Docket Item # 7 & 8  
BAR CASE # 2011-0103, 0104

BAR Meeting  
June 15, 2011

**ISSUE:** Permit to Demolish/Encapsulate & Addition

**LOCATION:** 519 Wilkes Street

Proposed Door

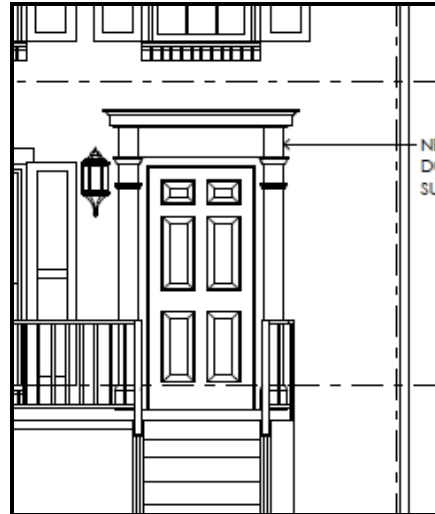
Revival style. Furthermore, Staff has no objection to the proposed height increase and conversion of the attic into a habitable third floor, the extension of the main roof, and the construction of the new dormer, as these alterations are minor in scale and massing. Staff does note that the existing door surround is being altered with a more high-style Colonial Revival surround with Doric pilasters and entablature.

Although, the trim and detailing on the existing entry doors along the blockface are modest; 513 Wilkes has a Colonial Revival portico with large frieze board and molded cornice, and 523 Wilkes has a two--story Colonial Revival porch, Staff feels that the high-style door surround proposed for 519 Wilkes would be compatible with the adjacent townhouses. Staff recommends that the Board support the installation of the proposed entry surround.
